From: [Sean Noonan](#)
To: [Edgar Gonzalez](#)
Subject: Comment on IS/MND for Tentative Tract Map 20637 (TT23-00004)
Date: Wednesday, February 18, 2026 4:03:47 PM

Tentative Tract Map 20637 (PROJECT)
 MITIGATED NEGATIVE DECLARATION (MND)
 SCH# 2026020360

Subject: The draft Initial Study and Proposed Mitigated Negative Declaration for Tentative Tract Map 20637 (TT23-00004) SCH# 2026020360

DRAWING NO. N-29C22-1
 SHEET NO. 115

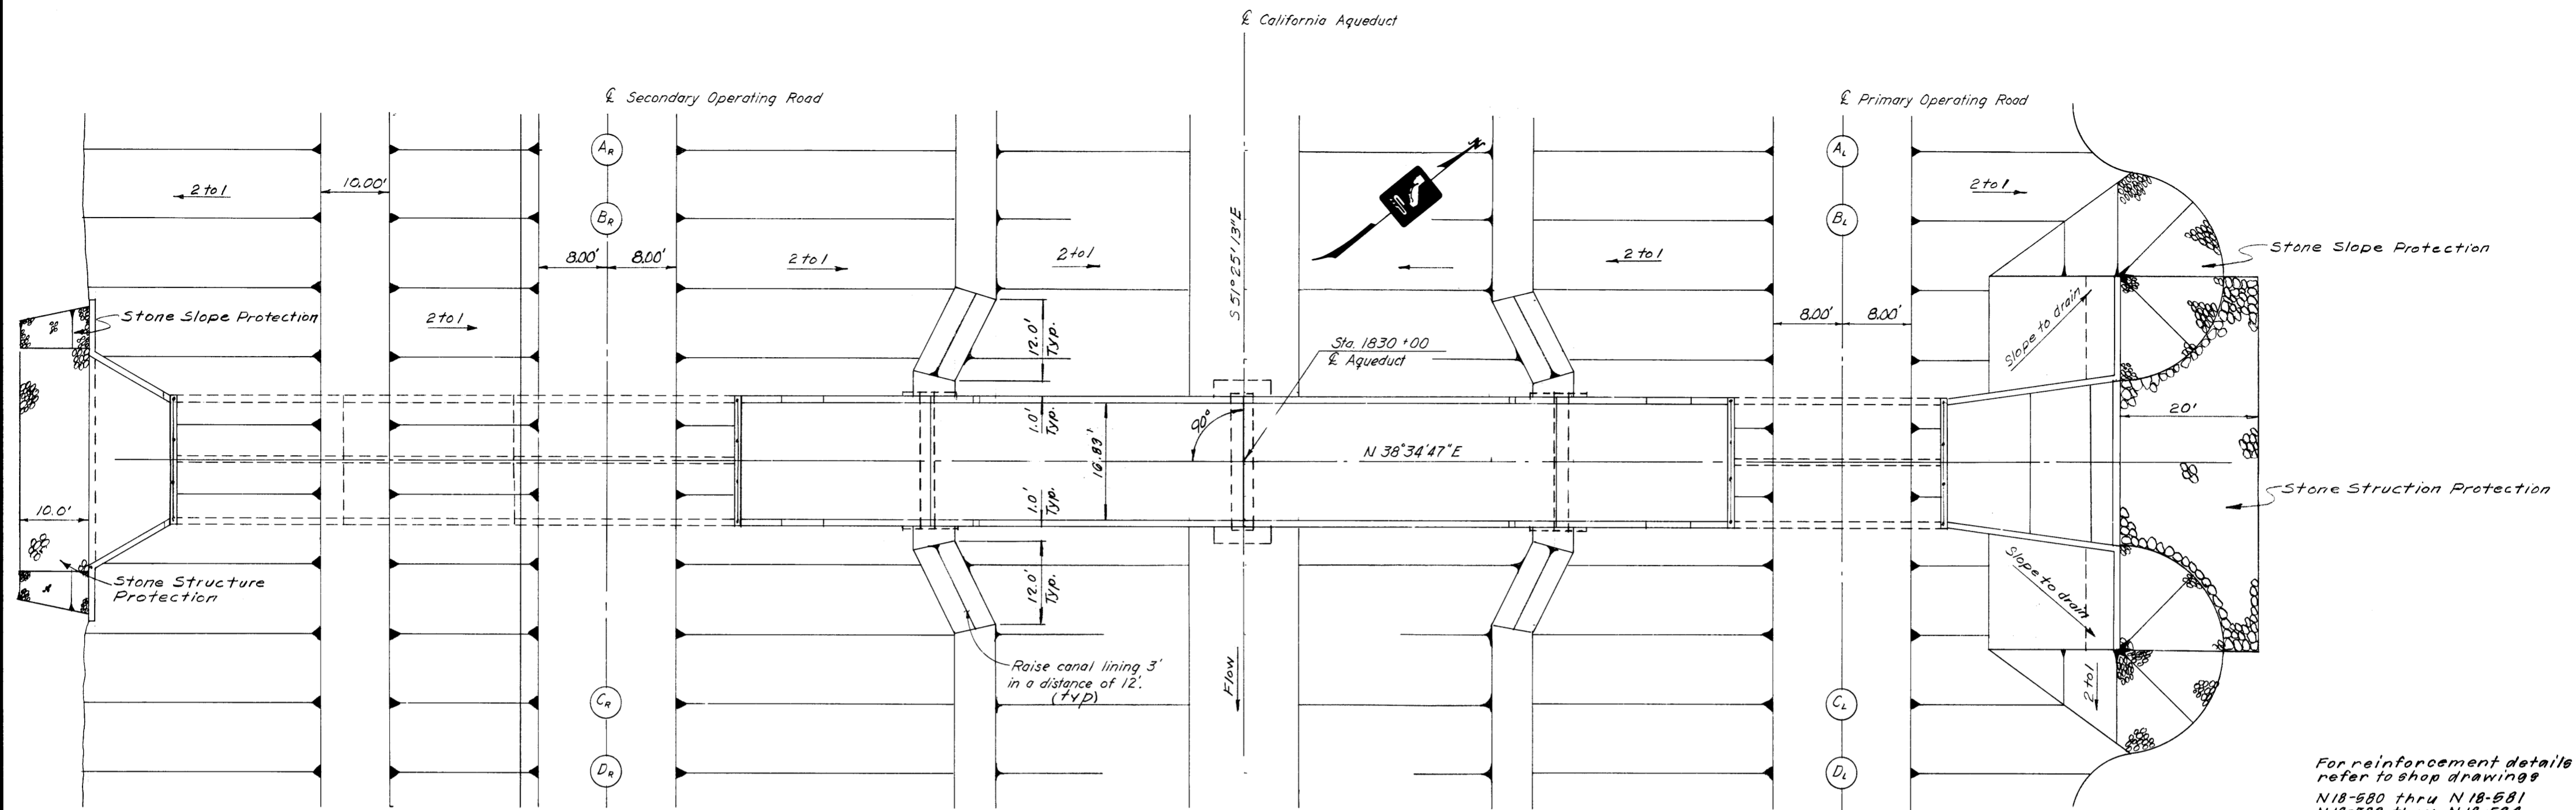
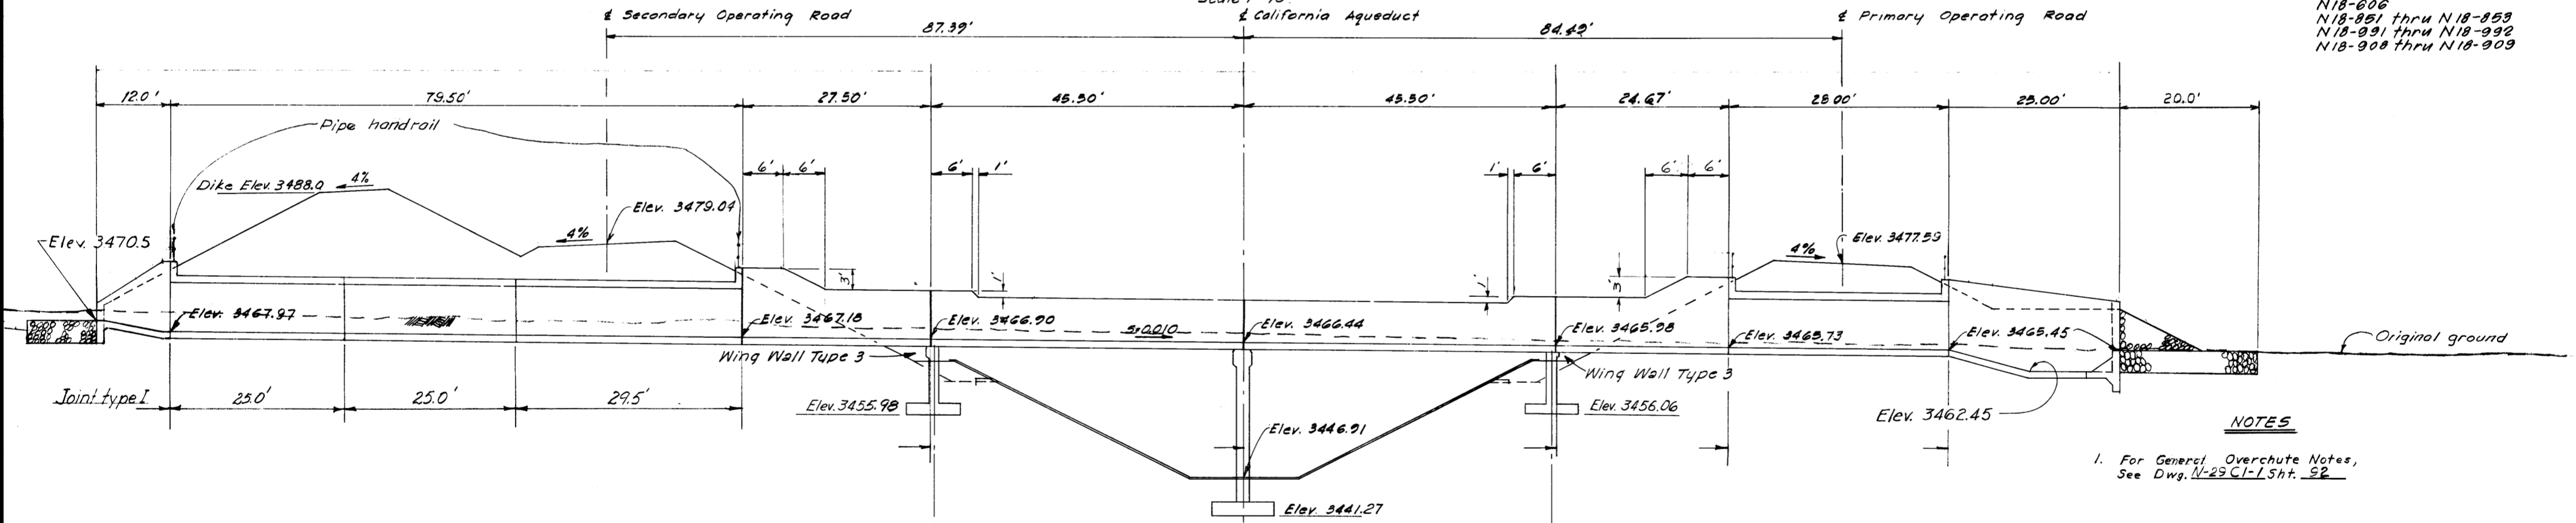
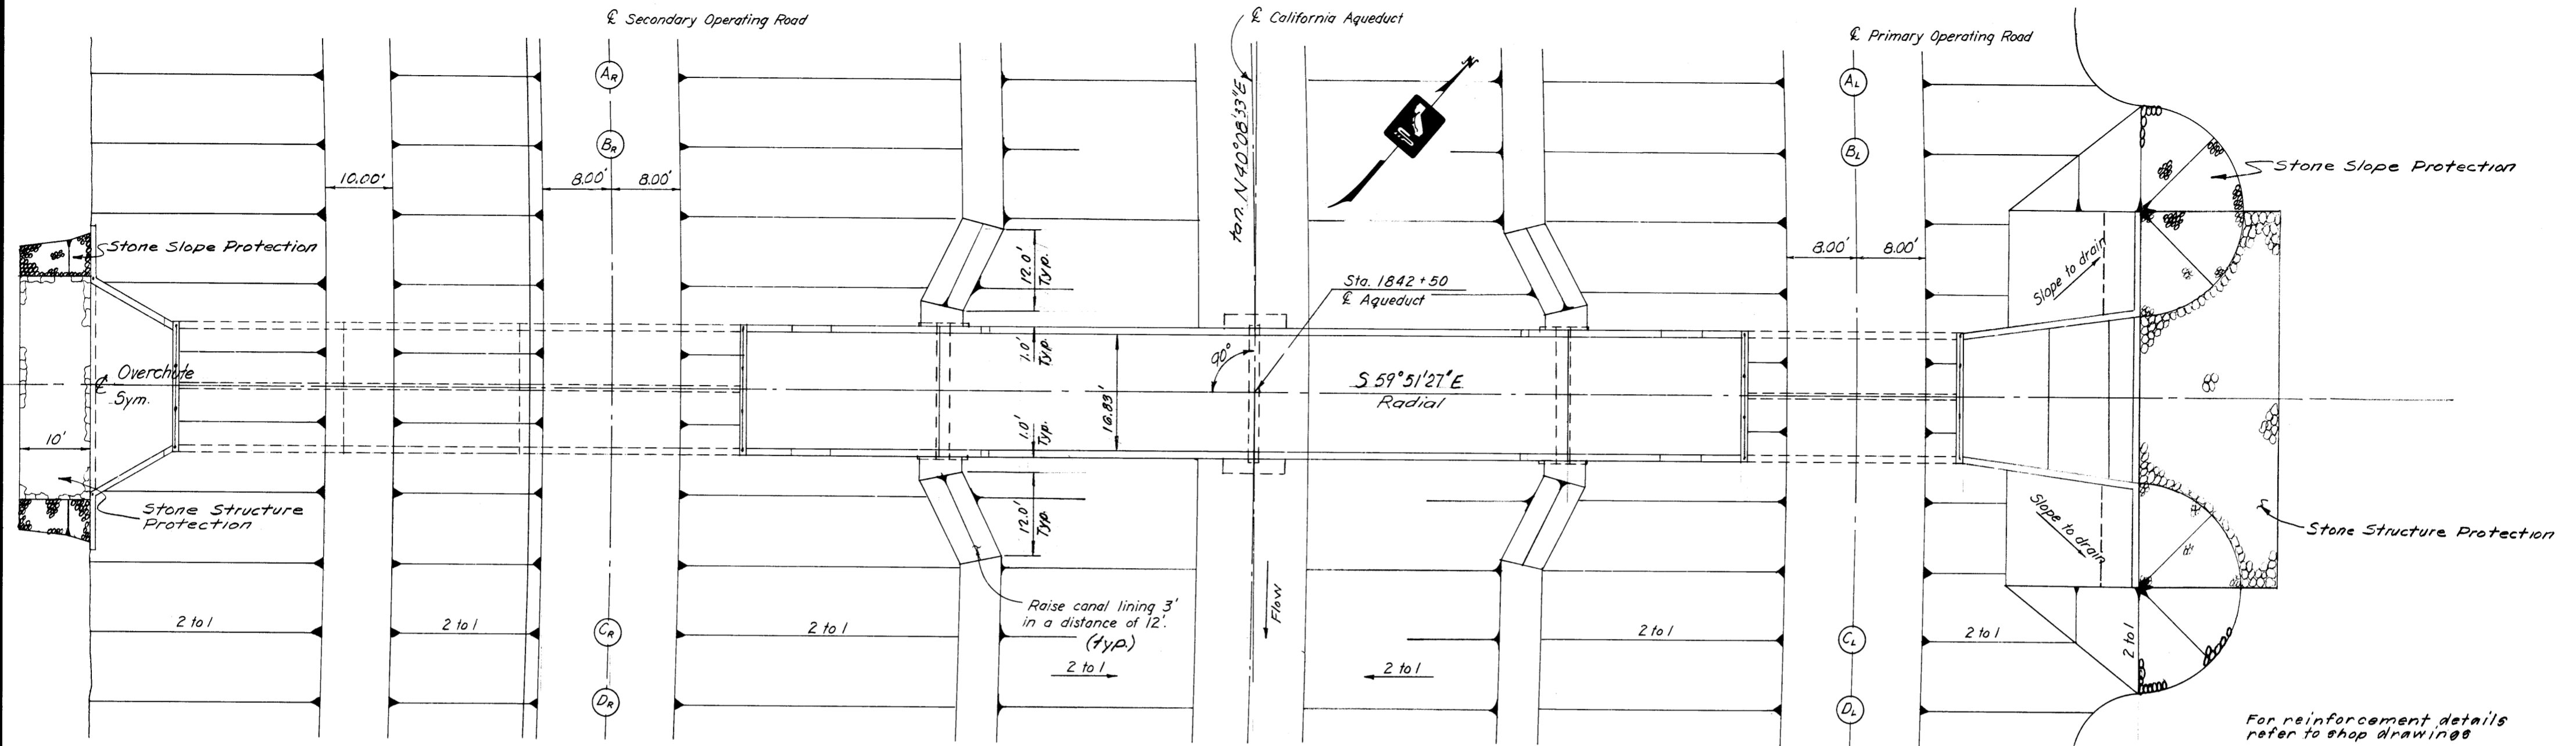
1. MP396.1 Overchute crossing over the Aqueduct located at the north end of Fuente Ave. See attached DWR As-built Drawing No. N-29F1-17, N-29C22-1, N-29C91-30.
2. MP396.4 Overchute crossing over the Aqueduct located at east end of Sultana St and DWR right of way west boundary. See attached DWR As-built Drawing No. N-29F1-18, N-29C24-1, N-29C91-31.
3. MP396.8 Overchute crossing over the Aqueduct located at east end of Pinellia St and DWR right of way west boundary. See attached DWR As-built Drawing No. N-29F1-18, N-29C23-1, N-29C91-31.

flows to this concrete lined ditch or the DWR Overchutes located at Mille Post 396.1, 396.4 or 396.8. All the Overchutes located along Aqueduct convey drainage flows from west to east side of the Aqueduct. Currently there is erosion on the outlet side of these Overchutes from the concentrated drainage flows from existing drainage basins listed above. This is mainly due to absence of concrete lined channel at the Outlet Side because concrete lined channels were only constructed up to the inlet structure as part of the adjacent development projects. The impact analysis for off-site erosion and siltation impacts needs to explain whether any potential overflow from proposed retention basin located at Lot A may flow to any of the drainage basins or DWR Overchutes listed above.

If the proposed development will divert drainage flows towards a nearby DWR Overchutes which currently receive concentrated flows from a development adjacent to the Proposed Project, additional Proposed Project flows are likely to increase the existing erosion within DWR right of way on the outlet side. Concrete lined channels on the downstream end may be needed to mitigate the Proposed Project erosion impacts. See attachment for DWR Hydrologic & Hydraulic Data which shows the structural capacities (cfs) of all the DWR Overchutes listed above. Hydrology and Drainage Analysis for proposed development is also needed to assess the flows (cfs) and flow velocities through DWR Overchutes to determine if energy dissipation structures or any improvements are needed on the inlet side within DWR right of way to prevent erosion, scour or damage to DWR Overchute Structures.

3. The County/Project Applicant shall ensure that no runoff from the proposed development enters DWR Right of Way and that any modifications to the natural discharge flows through DWR Overchutes do not result in backing-up of stormwater flows onto the DWR right of way.
